Liverpool Street Station

Planning Submission Ref: 25/00494/FULEIA

Embodied Carbon Assessment

The LISSCA Campaign: Save Liverpool Street Station

4.3. Comparison with GLA, NZCBS and LETI, benchmarks and targets/limits.

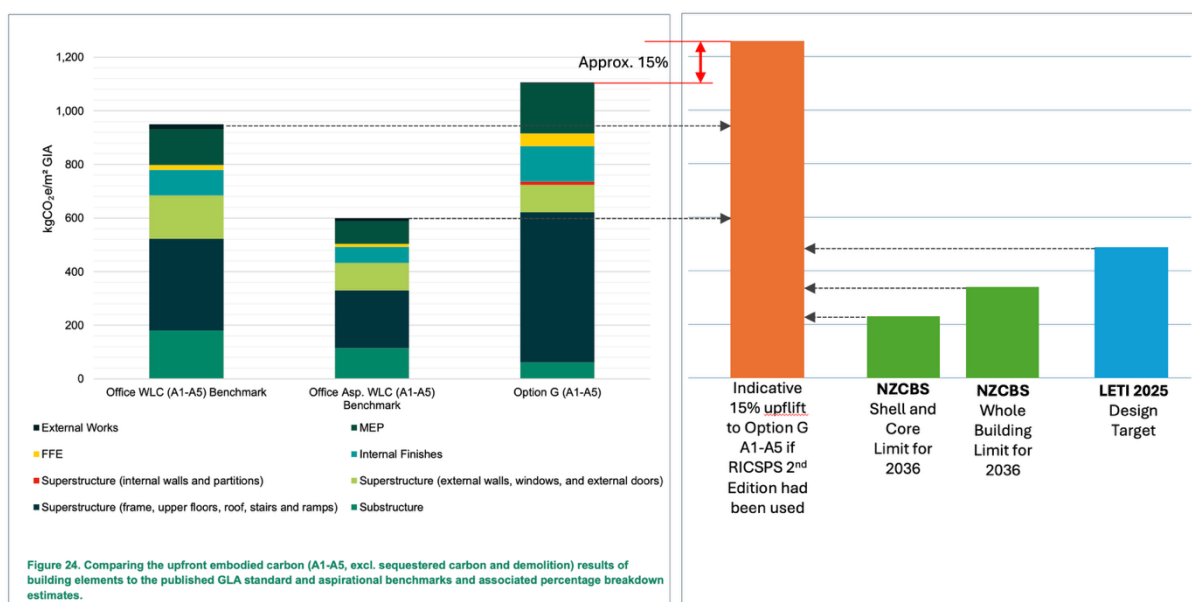
- The diagram below shows the Submission Diagram comparing the Option G, adopted scheme Upfront Carbon A1-A5 carbon assessment against the Standard GLA Office Benchmark, and also the Aspirational Benchmark.
- The **Orange** column shows 'Option G' with an indicative (and possibly conservative) corrected 15% uplift reflecting what the assessment is likely to look like had RICSPS 2nd Edition been correctly used for the assessment.
- The two **Green** columns show respectively the NZCBS 'shell and core limit' and the 'whole building limit' for offices completed in 2036. (It is the shell and core limit that will apply).
- The **Blue** column shows the LETI 2025 Design Target.
- The **black arrows** show the shortfall between the orange column, and the respective benchmarks, limits and targets.

- **Conclusion:** This combined diagram shows the likely uplift from using RICSPS 2nd Edition rather than the now redundant 1st Edition. It shows how much this building will miss the GLA 'Office WLC (A1-A5) Benchmark' (by approx. 33%), and the 'Office Asp. WLC (A1-A5) Benchmark' (over double).

- **Conclusion:** This combined diagram also shows that the orange, corrected, Option G column is nowhere near meeting industry best practice limits/targets illustrated by the green and blue columns. It is important to note that the NZCBS (Green) limits are designed to meet the government's required trajectory to net zero.

- **Conclusion:** In essence this proposal shows minimal ambition or intention to meet current best practice in terms of low carbon construction, or the UK's trajectory to Net Zero. Due for completion in 2036, only 14 years short of 2050, this building is has the potential to be commercially redundant on completion. Occupier and investor awareness of ESG issues is increasing, and therefore buildings such as this which have not evolved meaningfully past 20th Century Office design are highly likely to be downgraded in value. (See also paras 5.4 and 5.5 below).

5.2. The 'Carbon Optioneering Report P02' shows that initially 7 Options A-G were considered. See diagram below from 'Carbon Optioneering Part 1 p6:

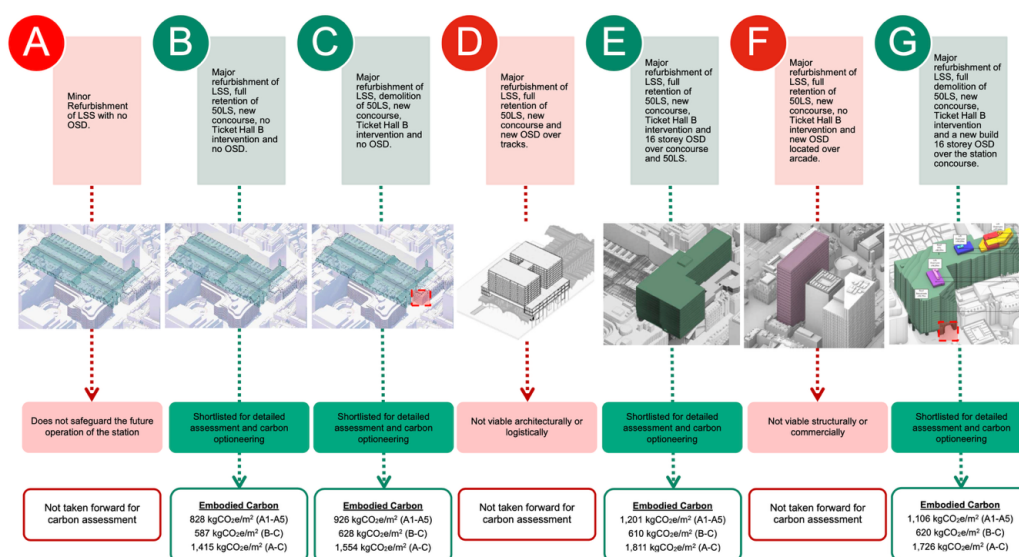
This rejects Options A, D, F in favour of a more detailed examination of Options B, C, E, G. Based on the applicant's assumptions on viability, and the need to pay for the station improvements, this in effect leaves only options E and G in contention. Options B and C appear to be retained really only to give a degree of validity to the optioneering as the clear requirement was to build a new office building in the location shown. This is a very restricted range of options, excluding other structural possibilities, see 5.3 below.

Figures 18 and 19. 3D model showing proposed transfer and stability structure over station concourse and OSD cores.

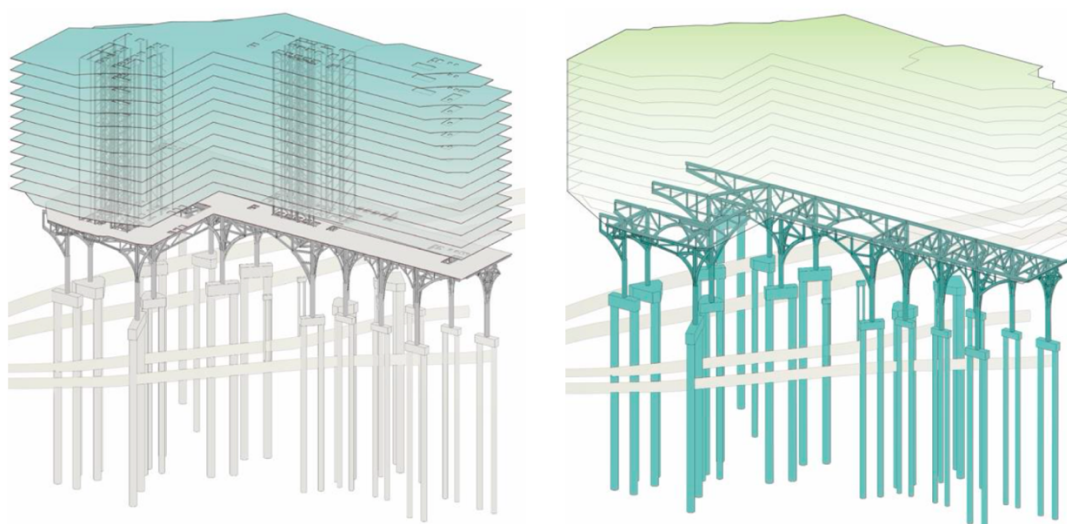
- In the Submission Document 'GLA Stage 2-3 Whole Life Carbon Assessment' para 1.6.3. there is the statement *"The upfront (A1-A5) carbon emissions of the transfer structure alone accounts for around 25% of 1,110 kgCO₂e/m². Without the transfer structure, the OSD may perform more favourably with the GLA's A1-A5 benchmark"*. This observation raises the question as to why a more imaginative solution wasn't examined that does not require a large transfer structure, which would have removed the need for this type of high carbon design approach, and potentially help reduce construction costs. The 'Carbon Optioneering Report P02' Option G p13 Figures 18 and 19, show the massive high carbon transfer structure that is required below.

- The structural solutions for both Options and E and G are essentially the same and involve a significant transfer structure over the station concourse to be achieved. It has already been stated in the submission that this design approach was exceptionally high carbon adding some '25%' to the assessment figures (see

Rejected Option D, "Carbon Optioneering Part 1 P02", p27, showing high carbon transfer structure.

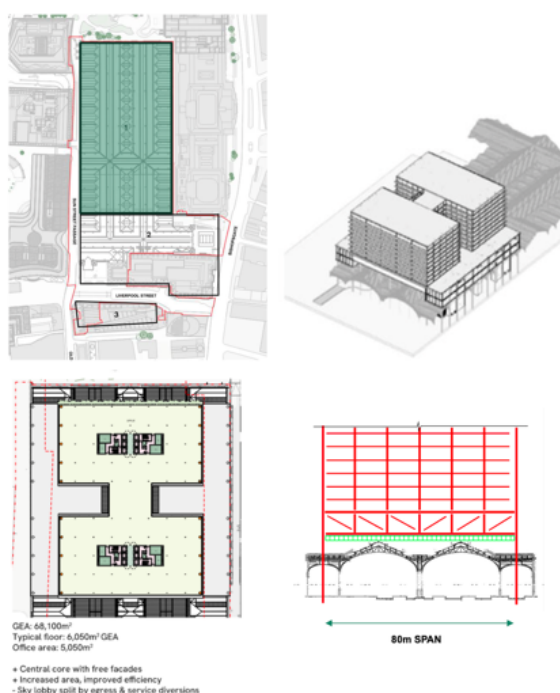
above para). The obvious solution to this problem is already evidenced on site with Exchange House which spans the tracks of Liverpool Street Station with a parabolic (tension) structure. This is potentially a much lower carbon approach which would very likely have avoided the '25%' additional carbon cost necessitated by the transfer structure. This would have brought the rejected Option D, described in the above diagram (5.2 above) as '*Not viable architecturally or logistically*' back into contention, as Exchange House has historically managed to solve both the architectural and logistical issues from building over the railway tracks at this station.

- Cross Laminated Timber (CLT) as a low carbon structural solution: CLT structural floors would seem to be a potential solution for this project solving two major issues, structural mass and carbon emissions. A basic structural problem with the submission is the weight bearing down on the transfer structure which would have been mitigated using CLT. In addition, CLT structural slabs would have not only have had a reduced carbon emissions impact from construction but could also have had a significant sequestration benefit. The reason given for this omission is '*Insurance*' concerns. However, Landsec's Timber Square Building in

Plate 4-15: OSD Façade Articulation Detail

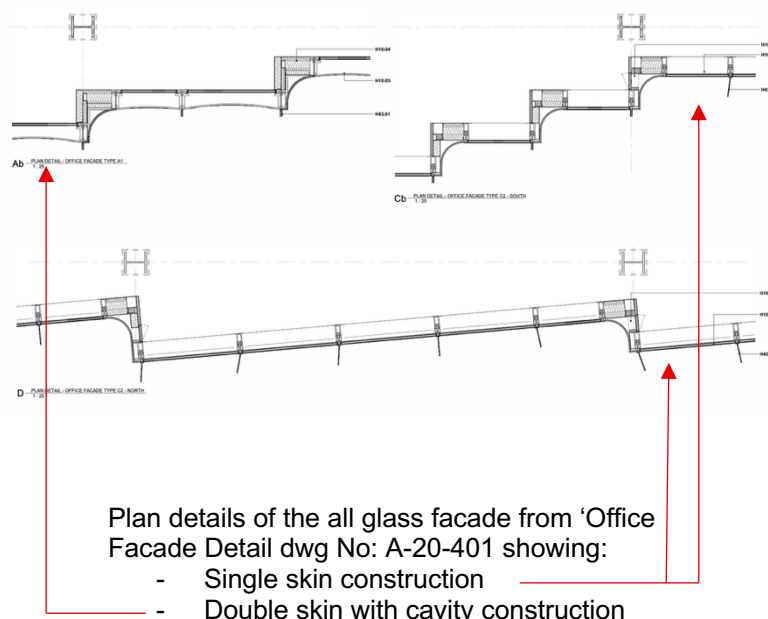
- The cladding for this building is a fully glazed unitised cladding system, no other design approach was considered in the Carbon Optioneering Report P02.

- This fully glazed facade has, according to the 'GLA WLC Template' included with the submission, a life expectancy of '30 years'. This means that as designed, it will need continual replacement roughly every 30 years with the resulting ongoing embodied carbon costs (greater in the double skin areas). 40 Liverpool Street was completed in 1884 and has had the same facade over the 140 years since then (plus maintenance, repair etc). Over a similar 140 year period the proposed scheme would therefore have to have its facade replaced a total of nearly 5 times (5th time at 150 years), with the associated resource use, carbon emissions, waste and local disruption.

Figure 22: Proposed energy strategy: Energy Hierarchy CO₂ baseline, emissions and savings – non-domestic buildings

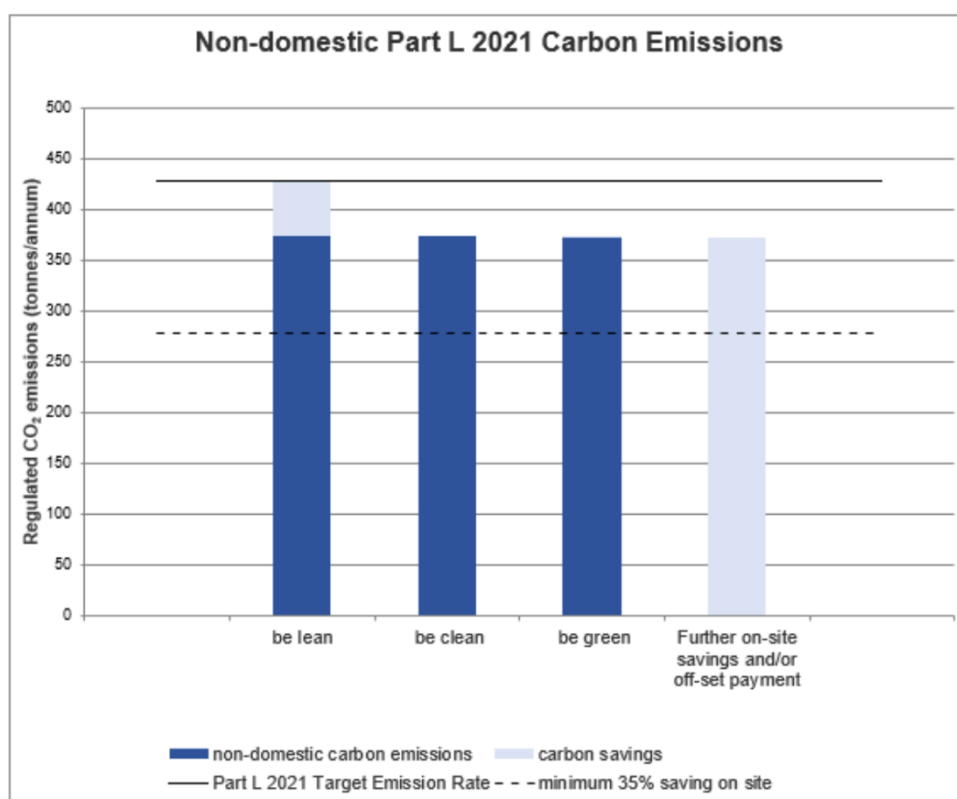
- This statement, astonishingly, shows that the submission for the OSD fully accepts that this building is substandard. The extract below from the ‘Energy Statement’, para 11.8.4, illustrates not only this failure but also the suggestion of an offset payment of £1,060,782 in mitigation. This offset payment was, it is assumed, considered a cheaper route to achieving a ‘zero carbon’ solution than designing a building that actually performs in accordance with best practice and current policies and targets (e.g. GLA ‘Be Lean’). This shows that this is not an ‘exemplary’ building (see 8.4 below).

11.8.4. The predicted shortfall in savings relative to the ‘zero carbon’ 100% regulated emission saving target is 372.2tCO₂/year, which is a cumulative total over 30 years of 11,166 tCO₂ that is expected to be addressed through offsetting. This results in an estimated carbon offset payment of approximately £1,060,782 subject to agreement with CoL. This is summarised in Figure 22 and Table 57.

Figure 12: Plan view of 7th floor showing facade types

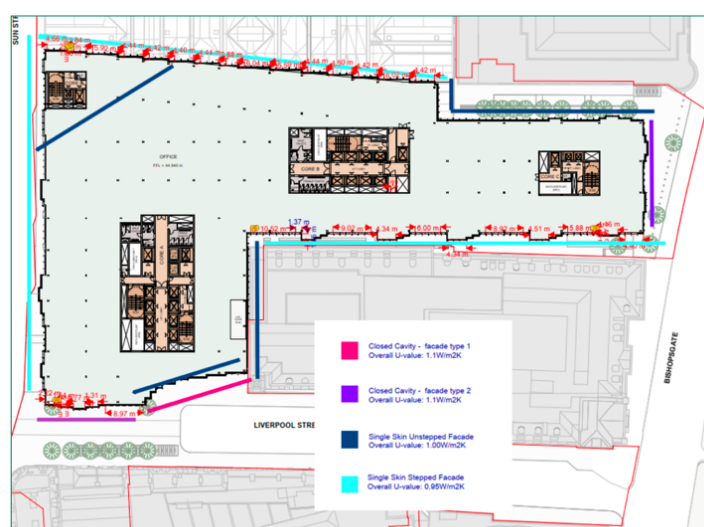
- The typical floor plan shown below (Submission ‘Energy Statement – Section 5: Energy Demand Reduction, para 5.1.3’) shows that the fully glazed facade is also inefficient in terms of wall to floor ratio. Apart from the inherently sub-optimum shape, the continual stepping of the facade adds to the overall surface area of the building, increasing material, i.e. embodied carbon costs, and is also consequently unhelpful to heat loss/gain. A more efficiently designed facade from both material and shape perspectives would contribute to greater facade longevity and improved operational performance. This floor plan cannot therefore be said to be ‘exemplary’ (see para 8.4 below, ref City Plan 2040 para 1.4)

- Inefficient floorplate
- Poor wall to floor ratio
- Inefficient stepped facade
- Short life, fully glazed facade

Demolition Site Plan – Extract from Dwg: A-04-200

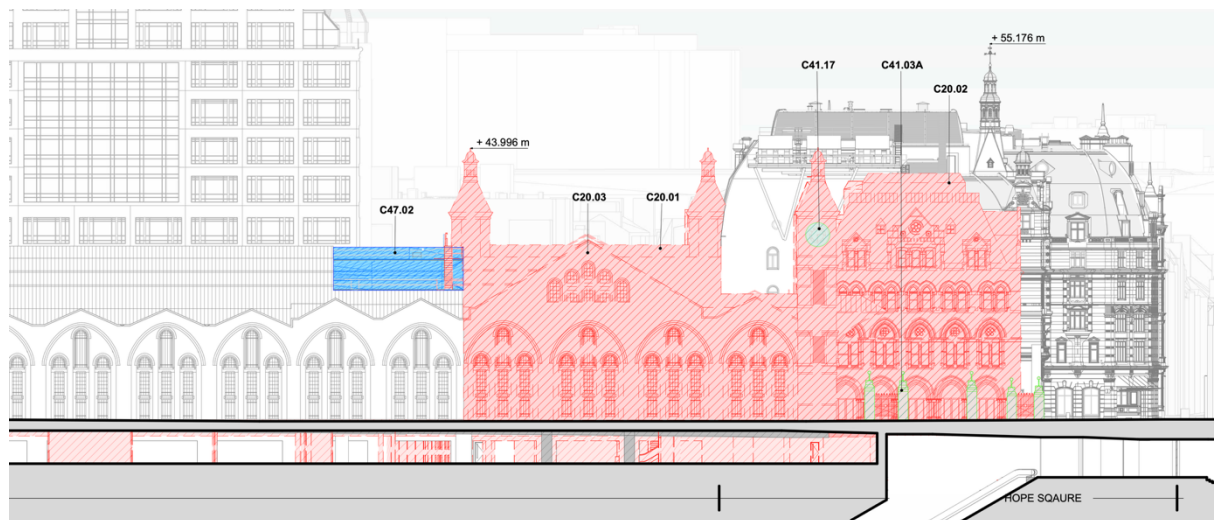
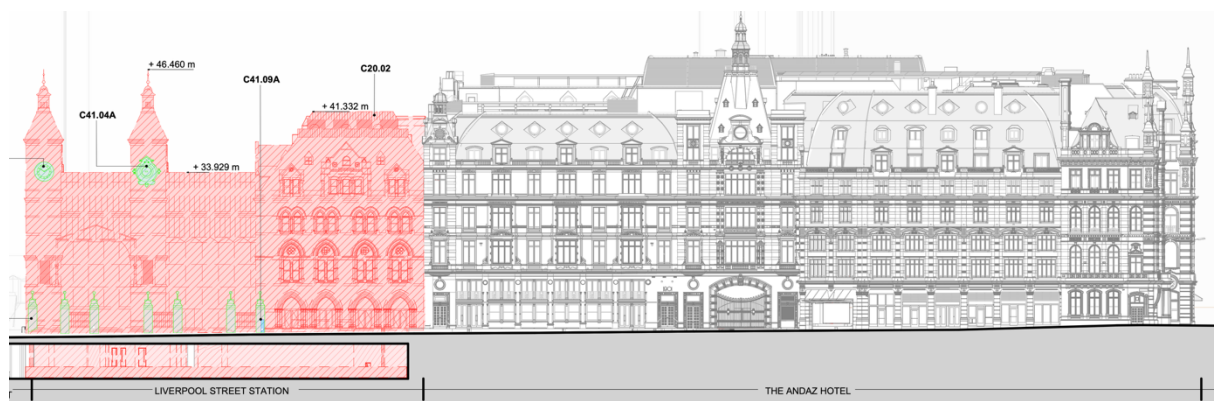
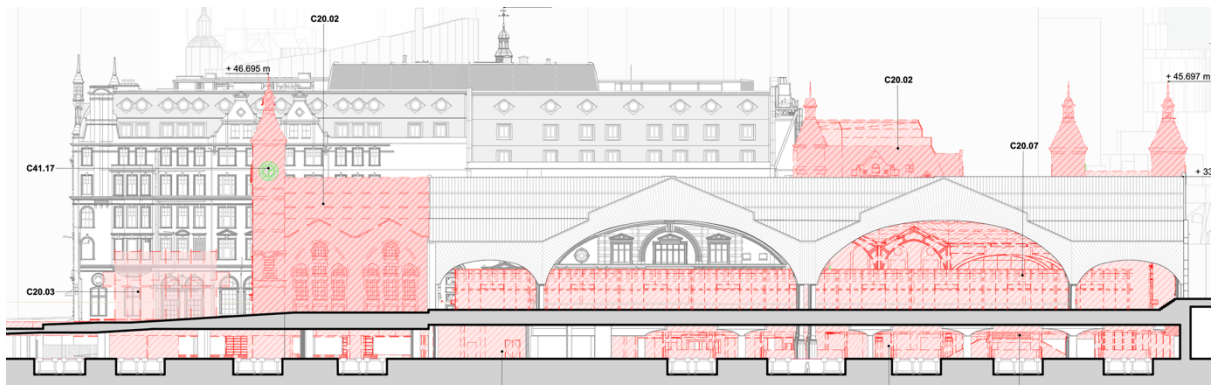
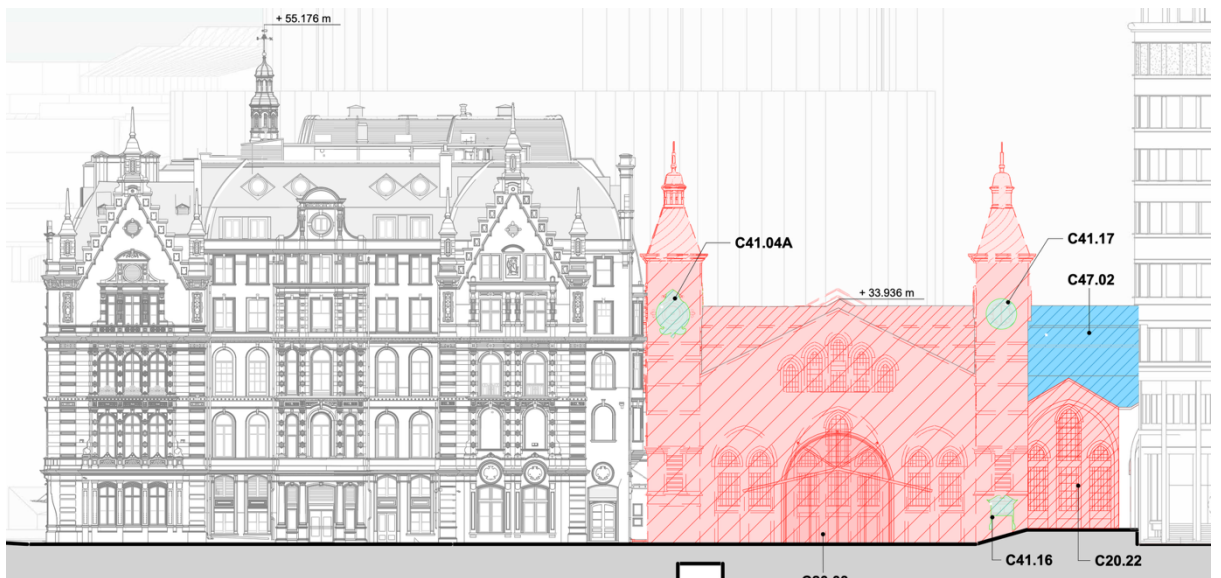
- The above are extracts from the submission documents and illustrate the significant amount of demolition of entirely useable structure and fabric to achieve this submission. The proposed scale of demolition represents a huge and unnecessary waste of resources. The issue of concern from a carbon and resources perspective is not the reorganisation of the station concourse areas, (assuming optimum resource and carbon efficiency is undertaken) but the demolition of useable assets that have not reached their end of their useful life and once retrofitted are capable of continued beneficial use.
